ATTACHMENT TO LICENSE AMENDMENTS

SAFETY EVALUATION BY THE OFFICE OF NUCLEAR REACTOR REGULATION
SUPPORTING AMENDMENT NO. 87 TO FACILITY OPERATING LICENSE NO. DPR-38

OCONEE NUCLEAR STATION, UNITS NOS. 1, 2, AND 3

These amendments revise the Station's Common Technical Specifications as applicable only to Oconee Units 2 and 3 by modifying the reactor vessel pressure-temperature operating limit curves to enable the extension of reactor vessel operation from 4 to 5 effective full power years.

Figure 3.1.2-1B

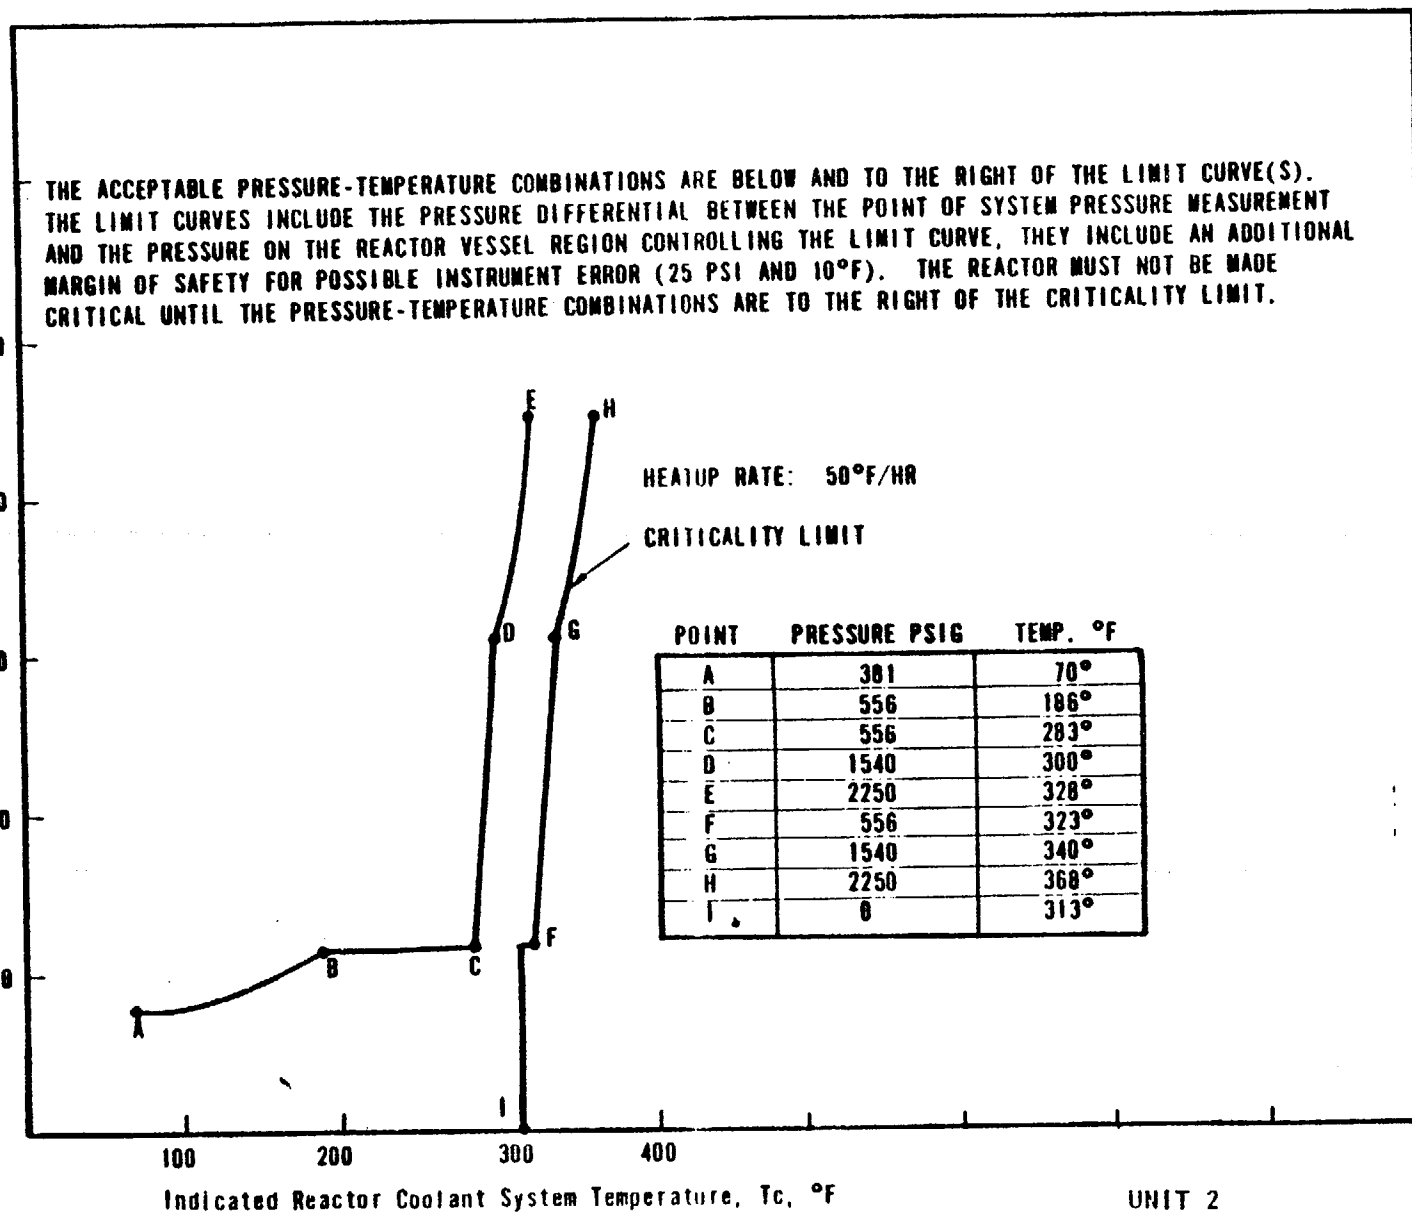
UNIT 2
 REACTOR COOLANT SYSTEM
 NORMAL OPERATION HEATUP LIMITATIONS
 APPLICABLE FOR FIRST 5.0 EFY
 OCONEE NUCLEAR STATION

The licensee has proposed that the current pressure-temperature limits for Units 1 and 2 be revised by increasing the allowable temperatures by 15° F to account for an increase in fluence corresponding to one EFPY. This would make the revised curves applicable for 5 EFPY instead of 4 EFPY.

We have evaluated the information submitted by the licensee and have concluded that his proposed revision will account for the increase in fluence that will result from an additional one EFPY of exposure, and that the revised curves will be in conformance with Appendix G, 10 CFR Part 50. Conformance with 10 CFR Part 50, Appendix G, constitutes an acceptable basis for satisfying the requirements of

Figure 3.1.2-1C

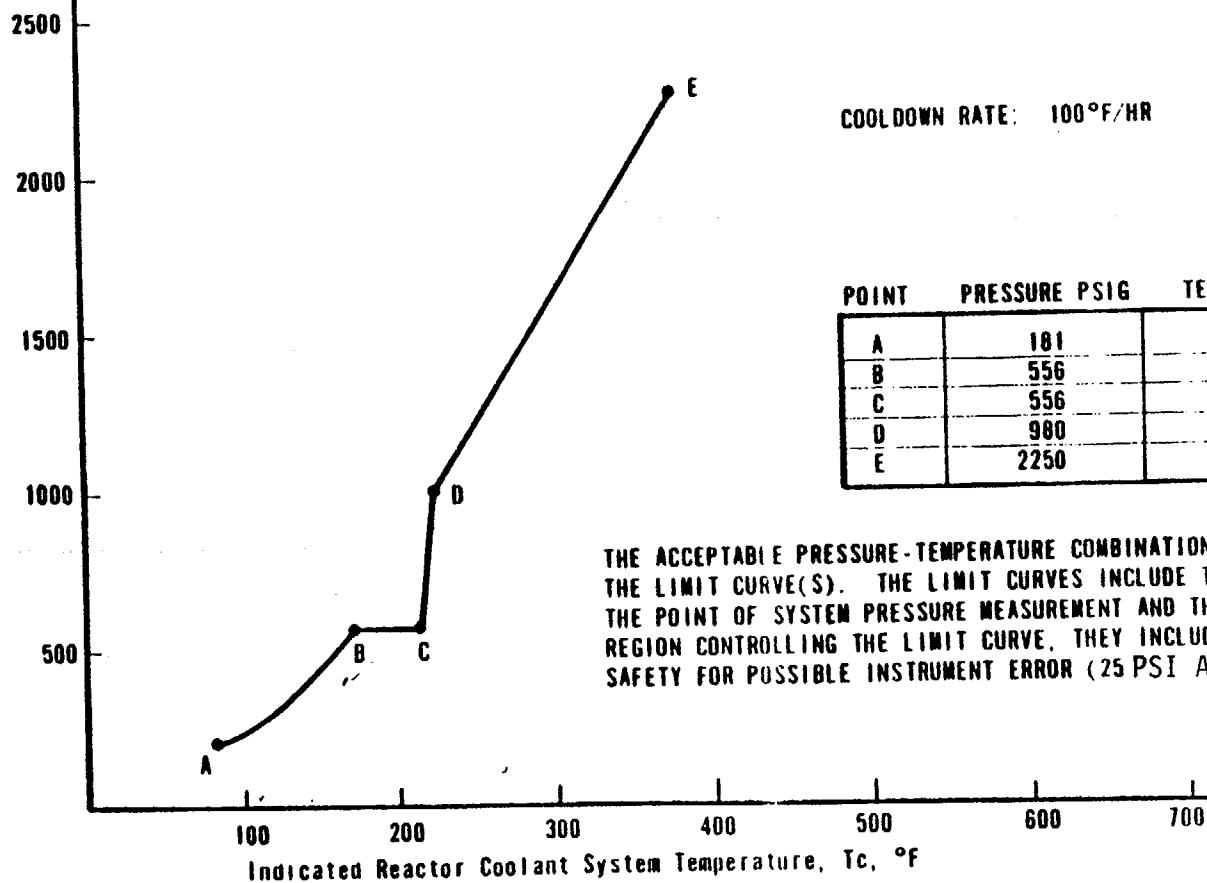
UNIT 3
REACTOR COOLANT SYSTEM
NORMAL OPERATION HEATUP LIMITATIONS
APPLICABLE FOR FIRST 5.0 EFY
OCONEE NUCLEAR STATION

Figure 3.1.2-2B

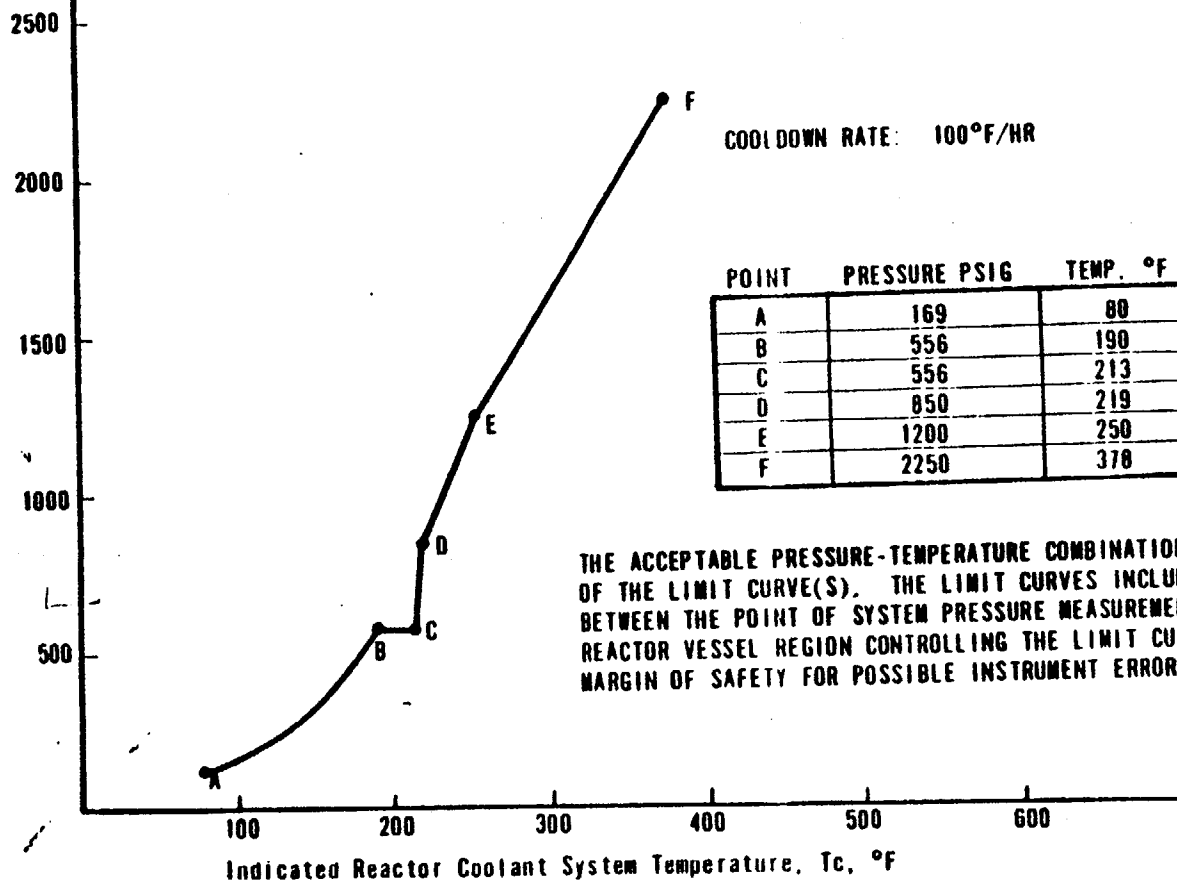
UNIT 2
REACTOR COOLANT SYSTEM
NORMAL OPERATION COOLDOWN LIMITATIONS
APPLICABLE FOR FIRST 5.0 EFY
OCONEE NUCLEAR STATION

Figure 3.1.2-2C

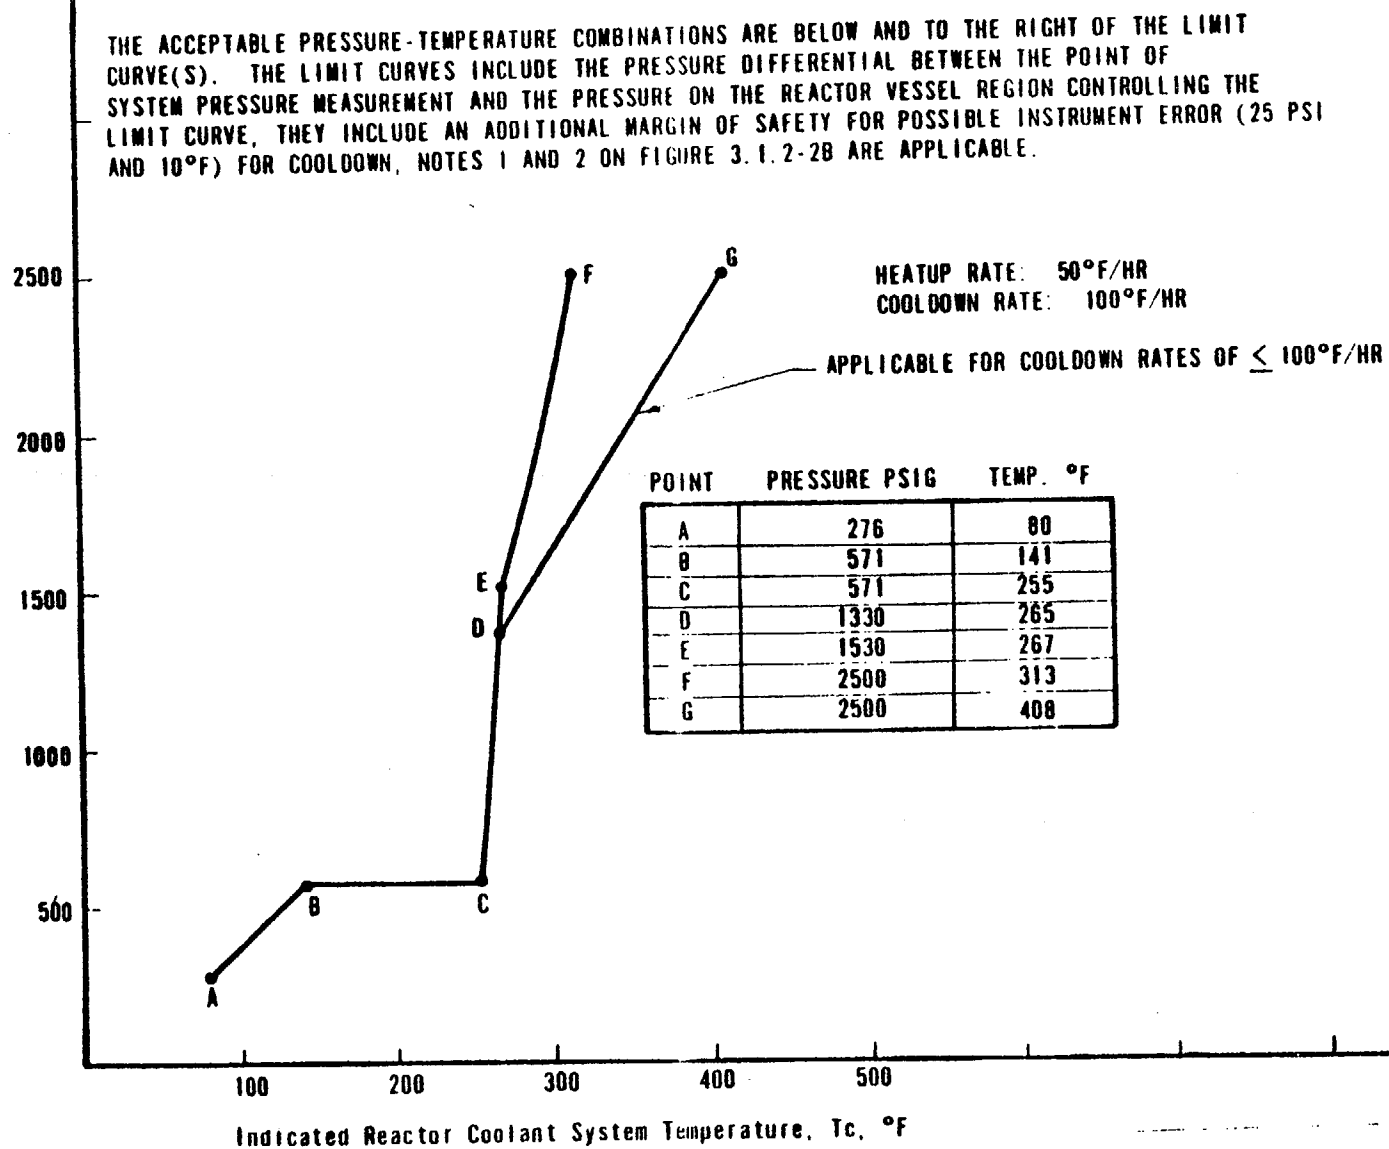
UNIT 3
 REACTOR COOLANT SYSTEM
 NORMAL OPERATION COOLDOWN LIMITATIONS
 APPLICABLE FOR FIRST 5.0 EFY
 OCONEE NUCLEAR STATION

Figure 3.1.2-3B

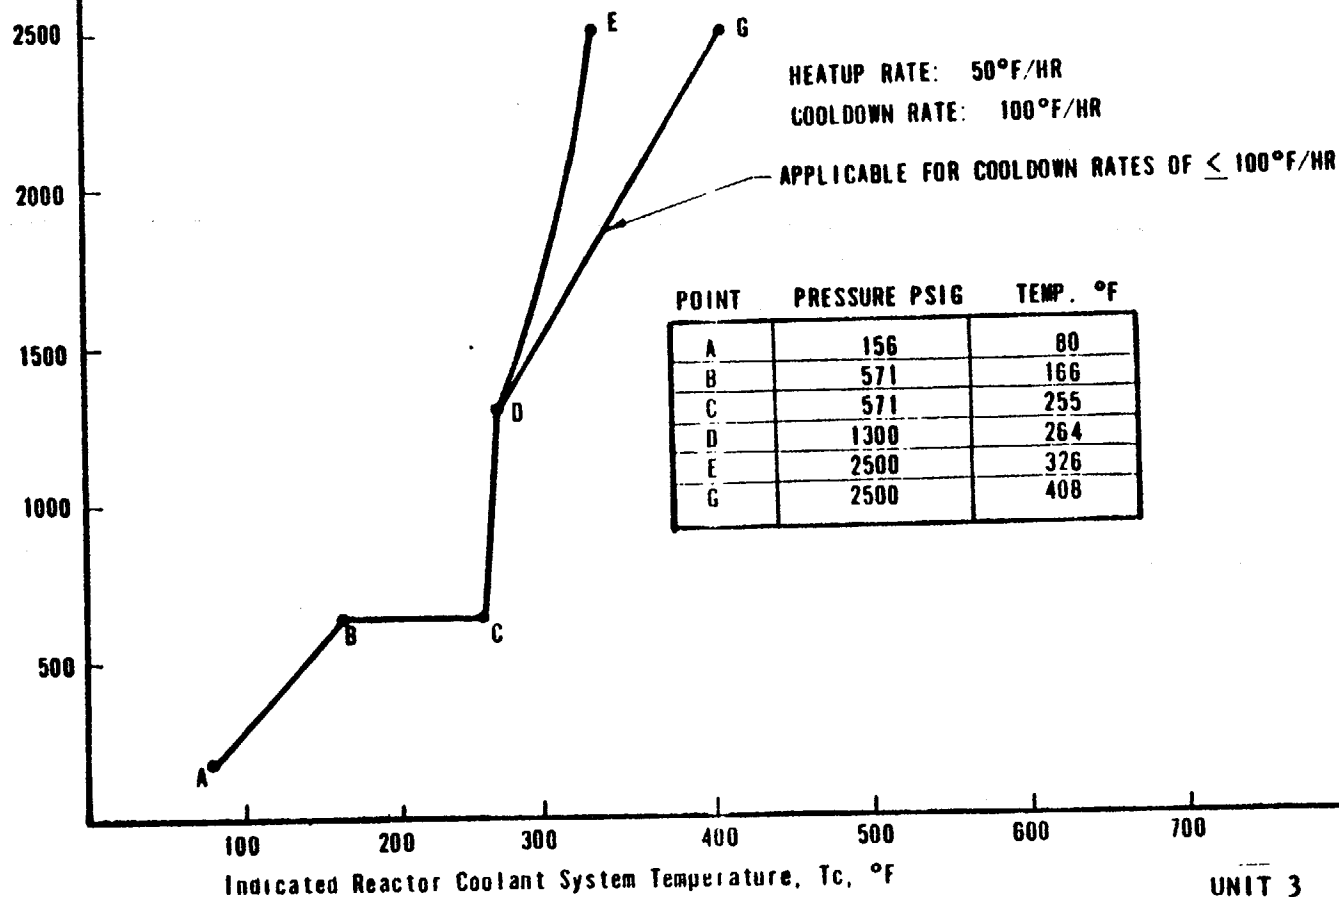
UNIT 2
REACTOR COOLANT SYSTEM
INSERVICE LEAK AND HYDROSTATIC TEST
HEATUP AND COOLDOWN LIMITATIONS
APPLICABLE FOR 5.0 EFY
OCONEE NUCLEAR STATION
